MEETING AGENDA

Planning and Zoning Commission

Village of Homewood

APPLICANT	Mahmoud Essa
ACTION REQUESTED	Site Plan Review, Special Use Permit
ADDRESS	18240 Harwood Avenue
PIN	29-31-312-007; 29-31-312-012; 29-31-312-020

Sheet Description:
PHOTOMETRIC

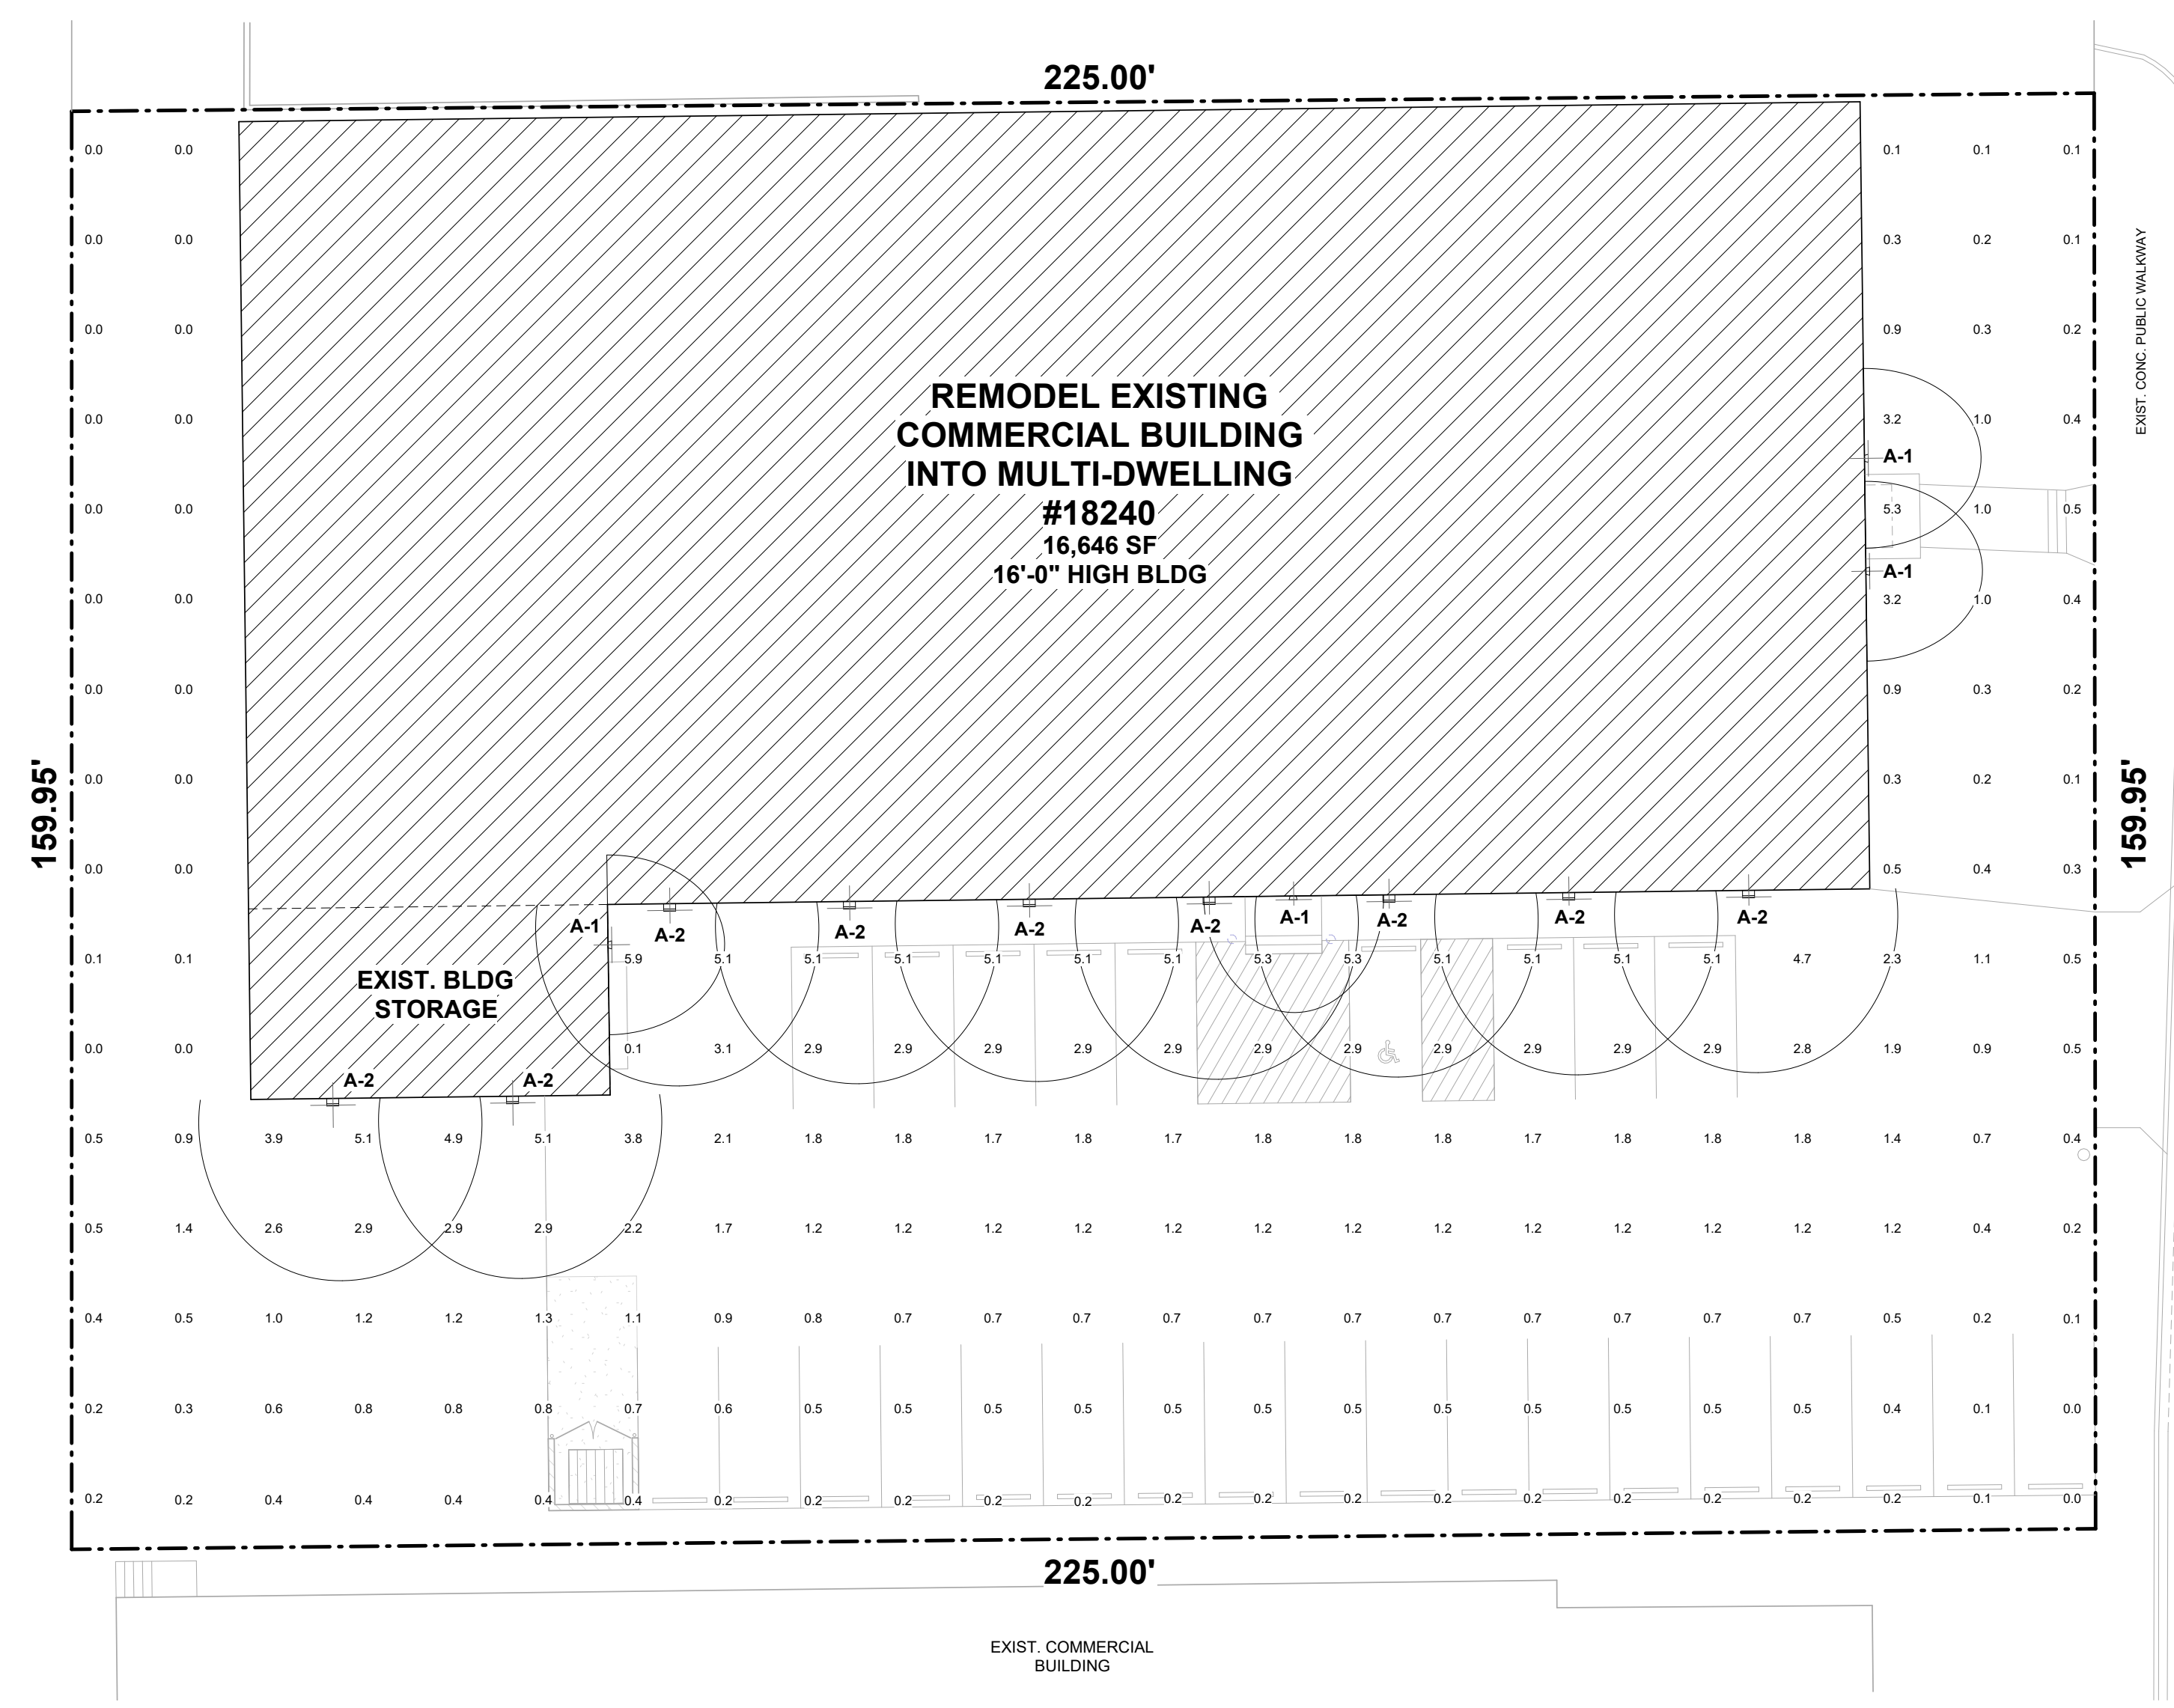
The existing building has minimal lighting, with two wall-mounted sodium-vapor sconce lights near service entrances to the building. The applicant will remove these lights and install new LED wall sconce lights along the southern side of the building to provide illumination in the parking area. The applicant will provide smaller LED sconce lights near building entrances, including two lights adjacent to the front entrance to the building.
